UNITED STATES OF AMERICA
NUCLEAR REGULATORY COMMISSION

(Beaver Valley Power Station
Unit No. 1)

ORDER FOR MODIFICATION OF LICENSE

AUDIT REPORT
PIPING DESIGN AND ANALYSIS

FIGURE 1B

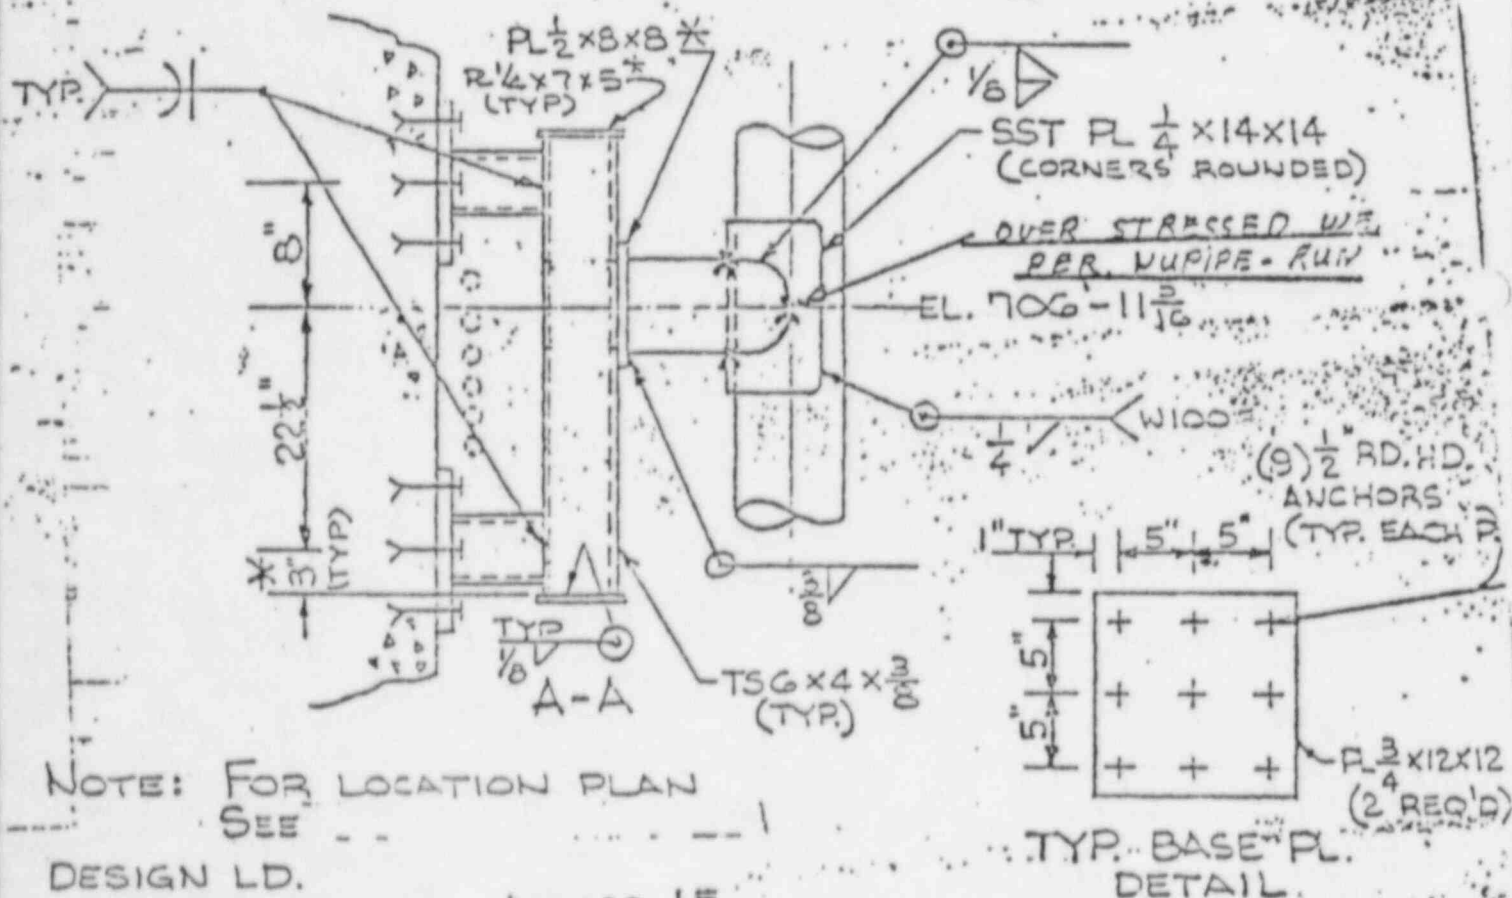
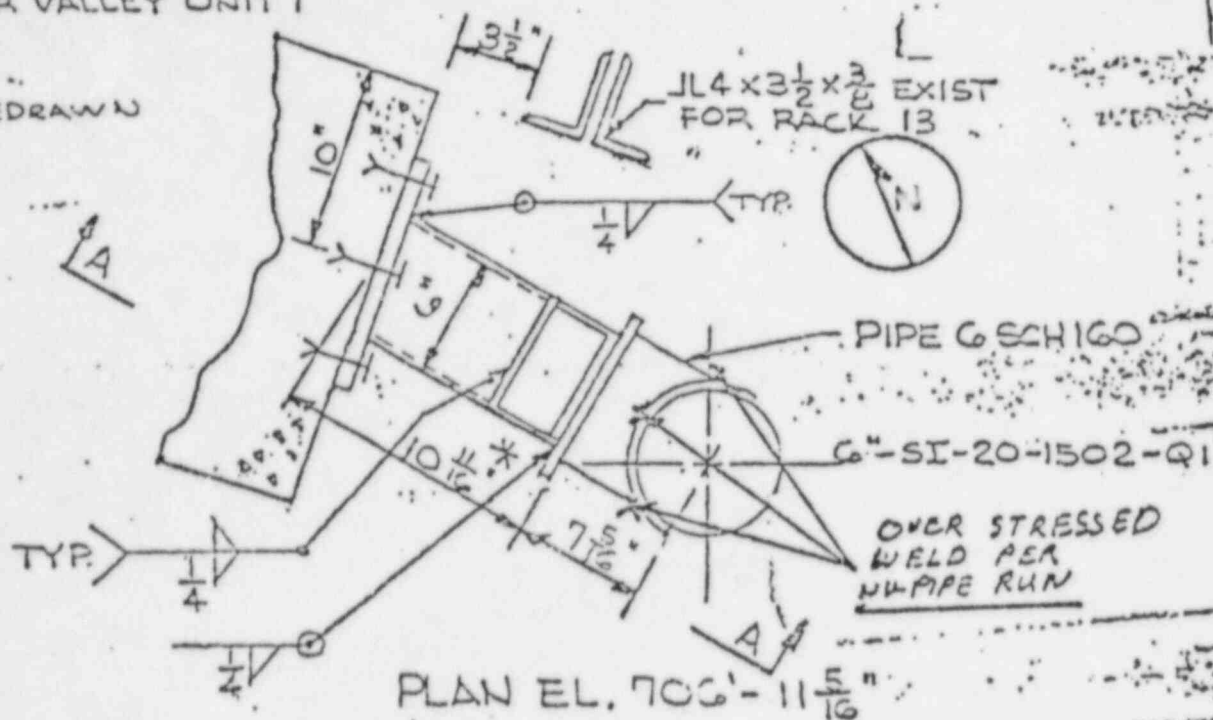
Figure IB is a sketch of the hangers-pipe (SI-A-60/6"SI-20) interface showing the overstressed area. The table attached to this sketch identifies the differences in the hanger attachment loads resulting from the two different computer models. Based on the above the Safety Injection line 6"-SI-20' is acceptable as designed.

POWER INDUSTRY GROUP		TITLE		SCALE: NONE	
CHECKED		H-60. HANGER-LOCATION LINE 6" SI-20.		DATE: 12-1-78	
CORRECT				SKETCH NUMBER	
APPROVED	<i>J. M. R. [Signature]</i>			FIG - 1A	
REVISIONS	(2)	(3)	(4)	(5)

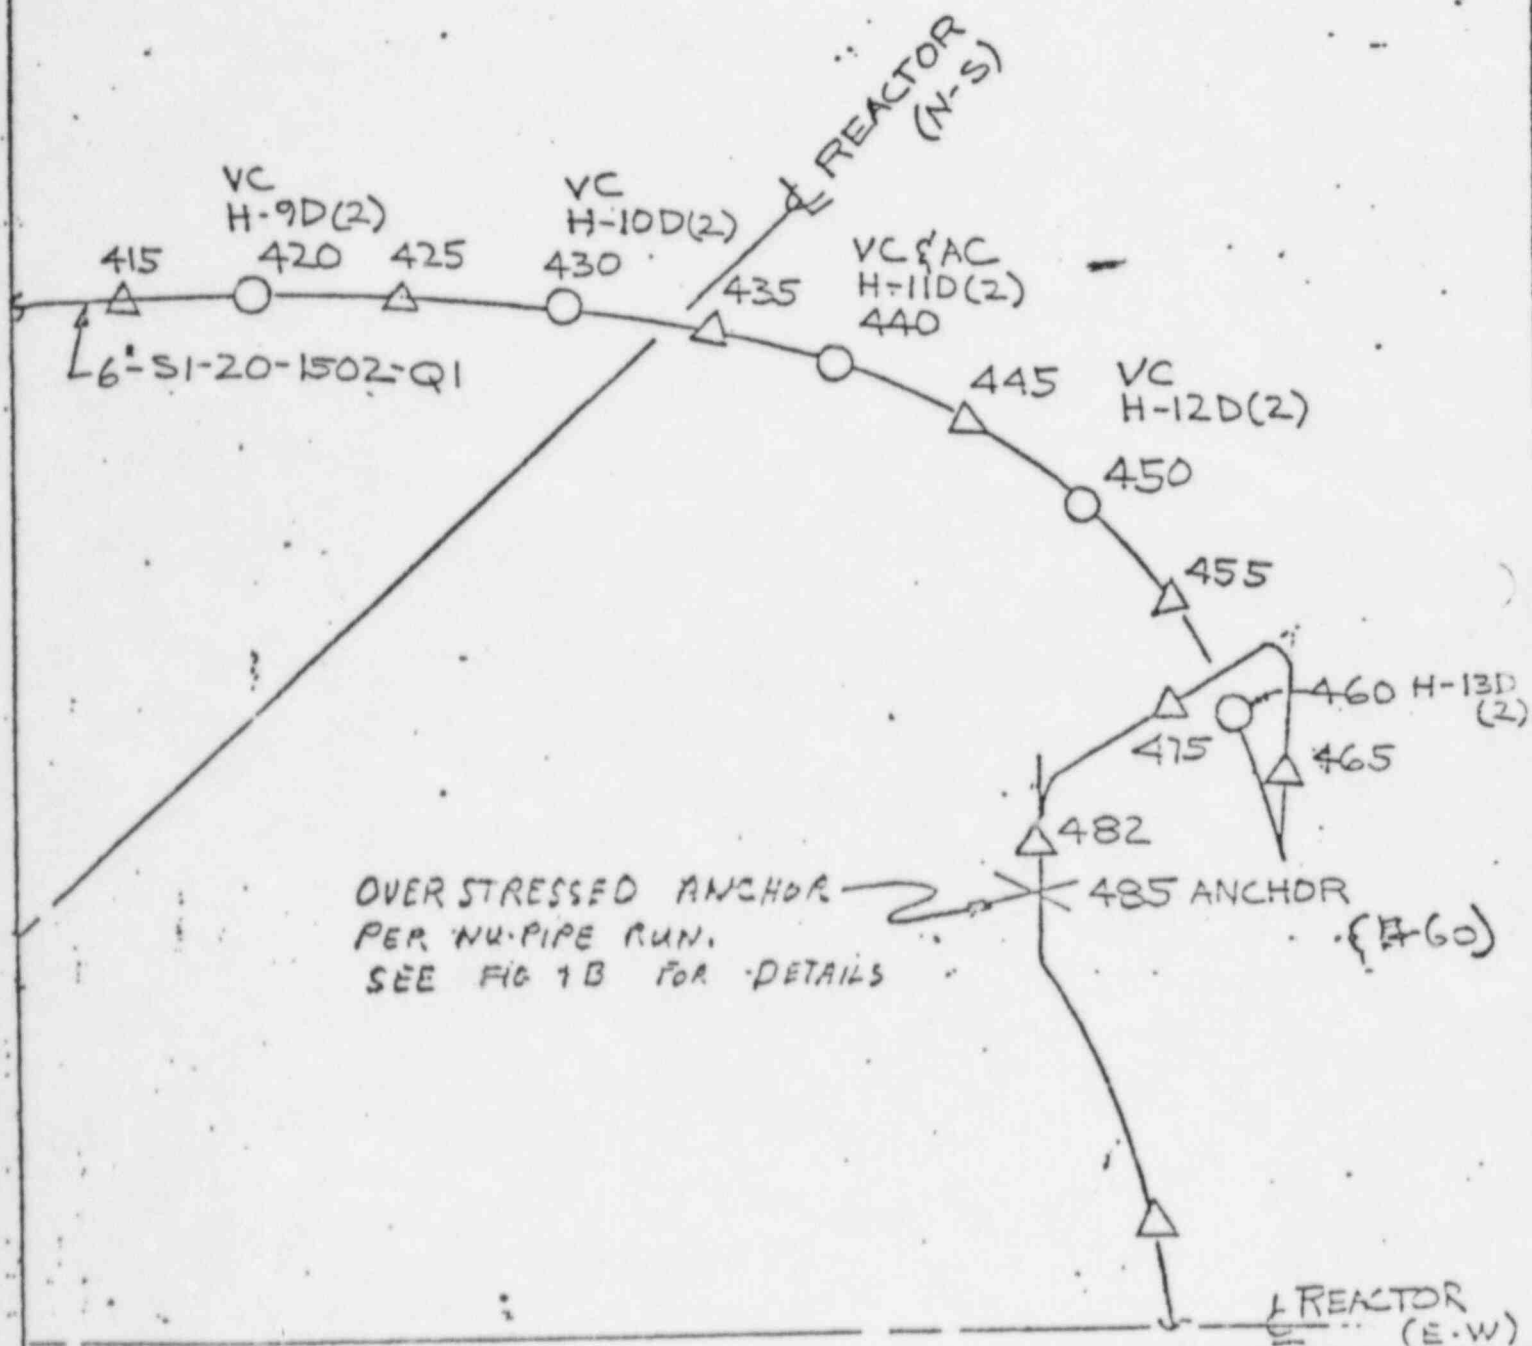
Figure IA gives the hanger location and peak local stress vs. allowable resulting from the NU-PIPE Model for line 6" SI-20.

FIG II A

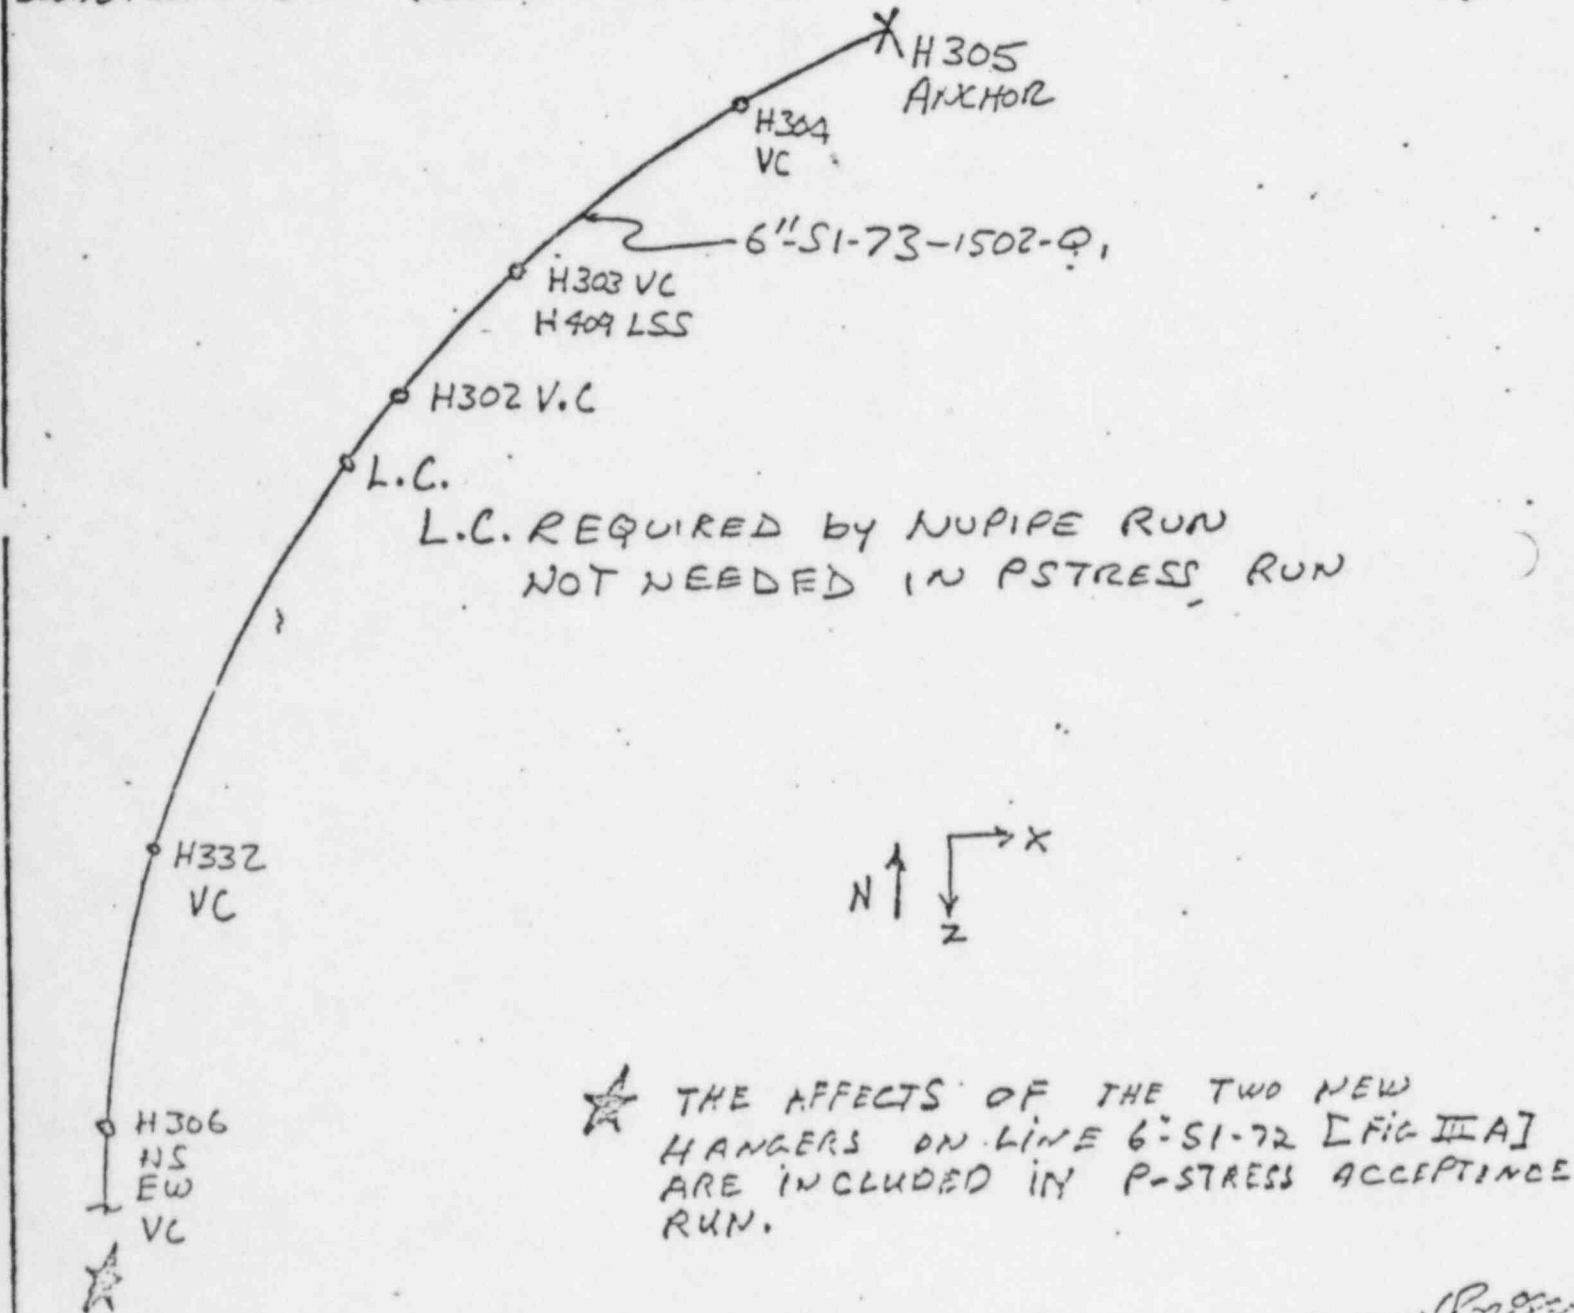
Figure IIA&B gives the most highly stressed hanger, location and stresses resulting from the NU-PIPE and P-STRESS runs on 6"SI-73. Based on this data, 6"-SI-73 is acceptable as design.
